MICHIGAN
STATE HIGHWAY DEPARTMENT

October 16, 1963

Subject: Investigation of Deck Cracking. EBI-96 Over the Grand River in
Grand Rapids. B02 of 41027A, C2. Research Project 63 B-72.
Research Report No. R-442.

Figure 1. Typical fine transverse crack mainly in outer pours.

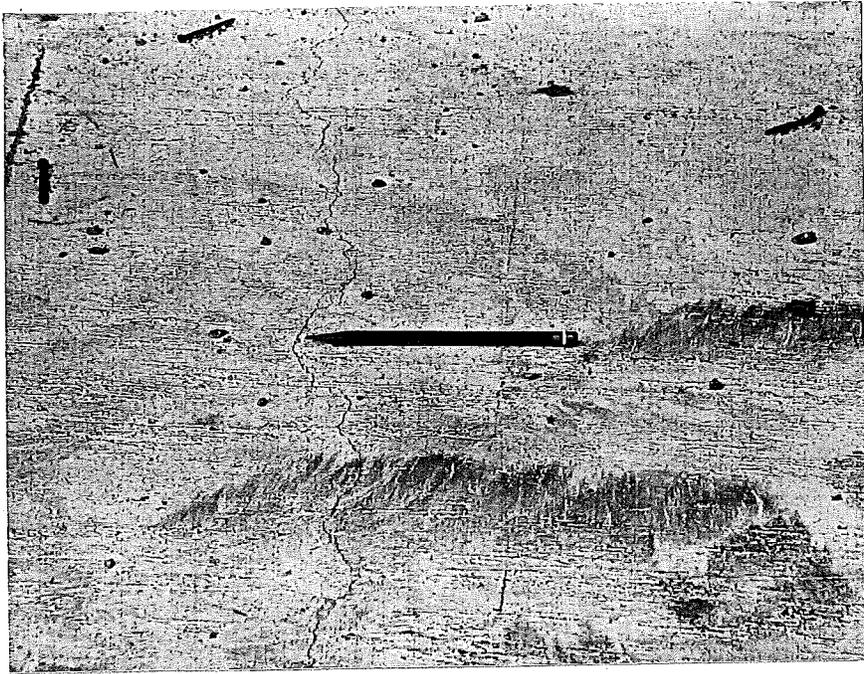
In all probability, the deck cracking is primarily due to plastic shrinkage caused by an excessive rapid evaporation of water from the concrete surface. Only one outside pour, FJM, had a low number of cracks and this was poured on the only cloudy and overcast day. Because the greatest amount of cracking occurred in the exterior lane pours, it is quite likely that a good deal of the cracking was also the result of induced tensile forces in the exterior lane pours brought about by an elongation of the structure as the temperature increased from early morning till late afternoon. The 24 foot central slab area which was poured first would greatly add to the heat absorption volume of the structure surface being heated, and the slab reinforcing would exert tensile forces on the freshly placed exterior segments as the structure elongated.

These corrective measures would include the following:

1. Utilization of cold mixing water.
2. Keep the aggregate ^{7. cool} ~~cool~~ by intermittent sprinkling of the stockpile or sprinkling successive layers as the stockpile is built up.
3. Shading the aggregate stockpile from the direct rays of the sun.
4. Keep the forms and reinforcing steel protected from the direct rays of the sun and cool by sprinkling.

5. Start curing the concrete as soon as possible after placing and finishing. Particular attention should be paid to having all facilities ready for prompt initiation of curing.

6. After placing, and before application of curing compound, keep surface moist with fog sprays.

7. Erect wind breaks to reduce wind velocity over the concrete surface.

8. Provide sun shades to control surface temperatures.

In addition, all exterior pours should begin in mid-afternoon, so that the structure would be in the process of cooling off and contracting during the time interval these sections were being placed. This would tend to put the fresh concrete in compression rather than tension as it cured.
